UNITED STATES
NUCLEAR REGULATORY COMMISSION
WASHINGTON, D.C. 20555-0001

SUBJECT: CLASSIFICATION OF HANFORD LOW-ACTIVITY TANK WASTE FRACTION

**REPORT ON
DOE HANFORD TANK WASTE CLASSIFICATION**

Figure 2-1. Estimate Hanford Site Tank Waste Radionuclide Inventory^{a,d}

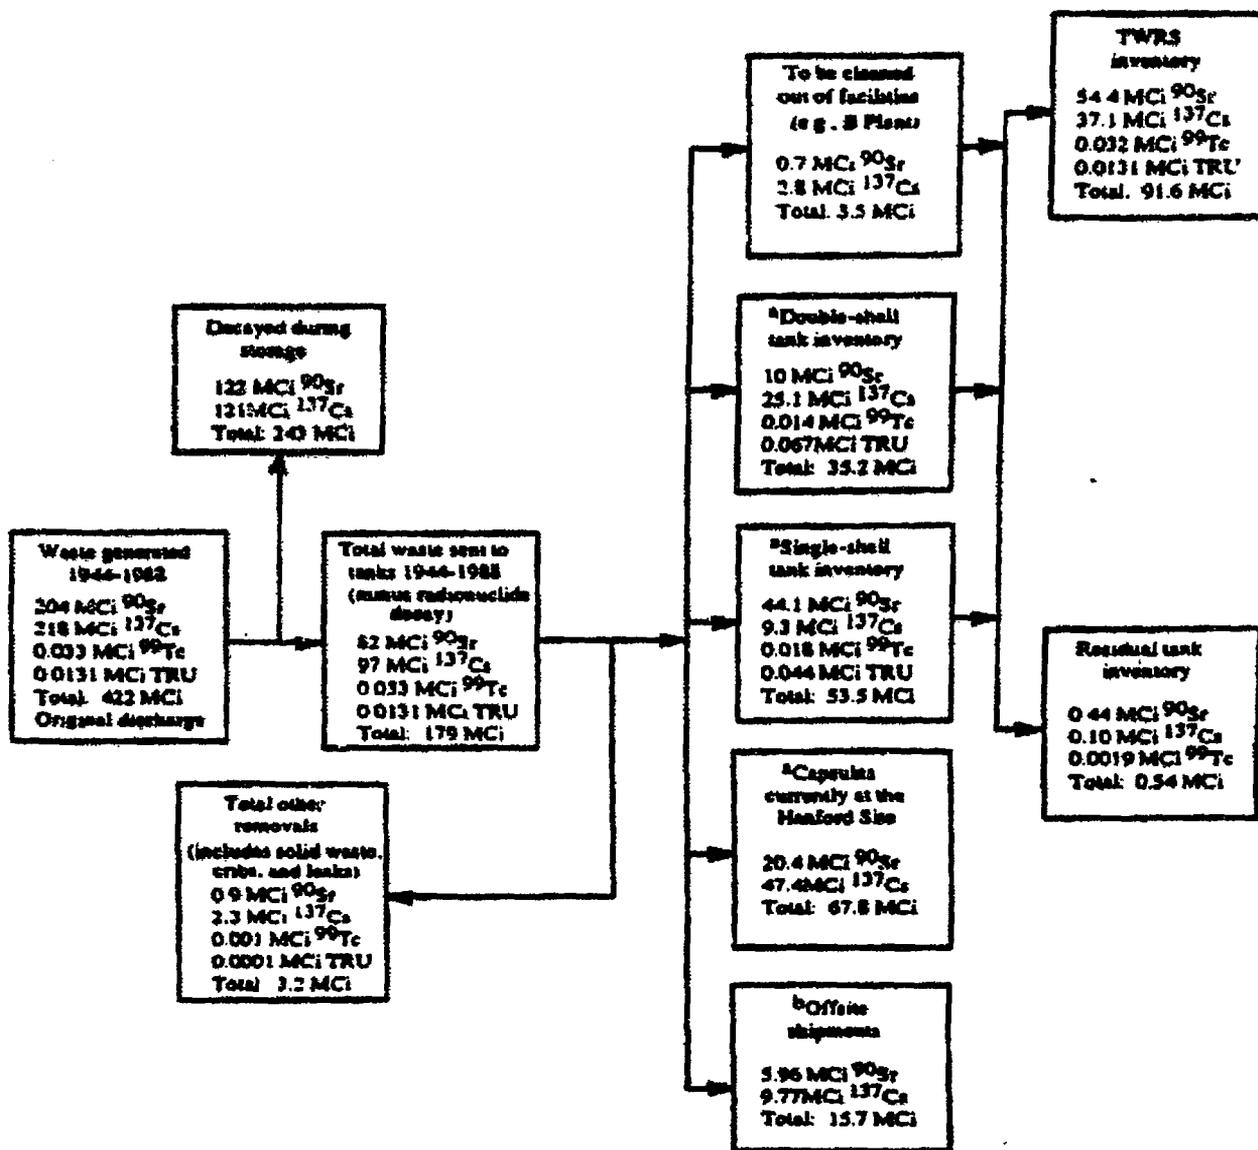
Figure 2-1, reproduced from the TBR (Westinghouse Hanford Company, 1996a, p. 3-2, figure 3-1), provides the estimated material balance for the Hanford Site tank waste radionuclide inventory. Figure 2-1 indicates that 243 MCi of the original tank waste radionuclide content of 422 MCi will have decayed by the year 1999. This value reflects the relatively short half lives of ¹³⁷Cs and ⁹⁰Sr. The material balance also indicates that approximately 87 MCi are accounted for as (i) leaks or deliberate discharges, (ii) encapsulation of ¹³⁷Cs and ⁹⁰Sr, (iii) other offsite shipments, or (iv) residual tank inventories. The remaining 91.6 MCi consists of 55.6 MCi insoluble waste to be disposed in a geologic repository as HLW and 36 MCi that comprises the soluble radionuclides that will be further treated to produce what DOE proposes to classify as incidental waste. This 36 MCi contains most of the ¹³⁷Cs and ⁹⁹Tc and almost all of the ⁷⁵Se, ¹²⁹I, ¹⁴C, and ³H (Westinghouse Hanford Company, 1996a, p. 4-1). After further treatment, 8.5 MCi will remain as incidental waste with 27.5 MCi being added to the HLW stream.

As shown in figure 2-1 of this report, 91.6 MCi comprises the Hanford Site tank waste inventory that will be processed for disposal as HLW or LLW. Approximately 99.9 percent of this waste is ¹³⁷Cs or ⁹⁰Sr. Initially, a simple solids-liquids separation will be performed on this waste to yield a low-activity liquid fraction containing the bulk of the nonradioactive materials, including about 3 percent solids carryover, and a high-activity fraction containing most of the solids. This solids-liquids separation process is expected to be relatively simple to complete and will remove approximately 55.6 MCi, consisting primarily of ⁹⁰Sr and TRU radionuclides (Westinghouse Hanford Company, 1996a, pp 3-2, 4-1, 4-2). Chapter 5 of the TBR concludes that, with the additional selective removal of transuranic wastes from three complexant concentrate tanks, and single-cycle ion exchange removal of ¹³⁷Cs from certain wastes,
